# SERVICE LETTER

No. 566

Piper Aircraft Corporation

<u>Subject:</u>	AutoPilot Servo Spacer Bushing Installation
<u>Models and Serial Numbers Affected:</u>	All the following aircraft with a III Series Automated Flight Control System (and AutoFlite, re Cherokee models) Installation:
<u>Models Affected:</u>	<u>Serial Numbers Affected:</u>
PA-23-250 (Six Place) and PA-E23-250 (Six Place) Aztec;	27-3837, 27-3944 to 27-4467 incl., 27-4469 to 27-4488 incl., 27-4490 to 27-4514 incl., 27-4516 to 27-4527 incl., 27-4530 to 27-4535 incl., 27-4537 to 27-4547 incl., 27-4549, 27-4551, 27-4552, 27-4554 to 27-4561 incl.
PA-24-260 Comanche;	24-4783, 24-4804 to 24-4948 incl., 24-4950.
PA-28-140/180/235 Cherokee;	(140) 28-24689 to 28-26946 incl. (180) 28-5058 to 28-5859 incl. (235) 28-11078 to 28-11378 incl.
PA-28R-180/200 Cherokee Arrow;	(180) 28R-30881 to 28R-31270 incl. (200) 28R-35001 to 28R-35820 incl.
PA-30 Twin Comanche;	30-1717, 30-1745 to 30-2000 incl.
PA-31 and PA-31-300 Navajo;	31-256 to 31-536 incl., 31-538 to 31-611 incl., 31-613 to 31-639 incl., 31-641 to 31-649 incl., 31-651 to 31-661 incl., 31-663 to 31-670 incl., 31-672 to 31-675 incl., 31-677 to 31-685 incl., 31-687, 31-689, 31-69

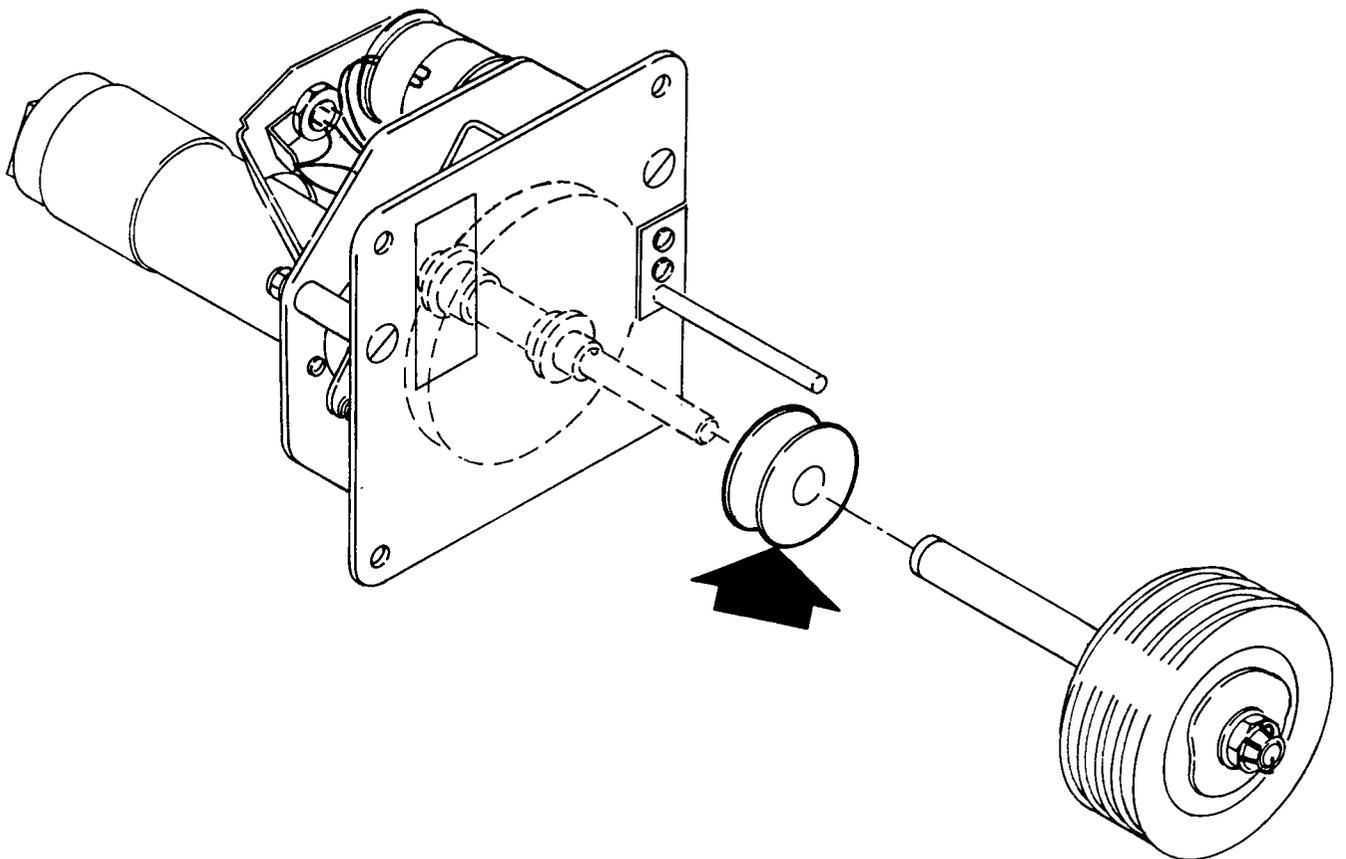
Purpose: To provide material and instructions for the installation of a spacer bushing to fill the space between the servo capstan and frame (reference attached sketch for an illustrated description).

Instructions: Contained in III Series AutoPilot Servo Spacer Bushing Installation Kit Nos. 760 472, 760 473 and 760 508V (reference Material Required, below).

NOTE: One each Servo Spacer Bushing Installation Kit will modify one servo; therefore, aircraft with a III Series AutoPilot (i.e., two servos per aircraft) will require two each of the appropriate servo spacer bushing installation kits.
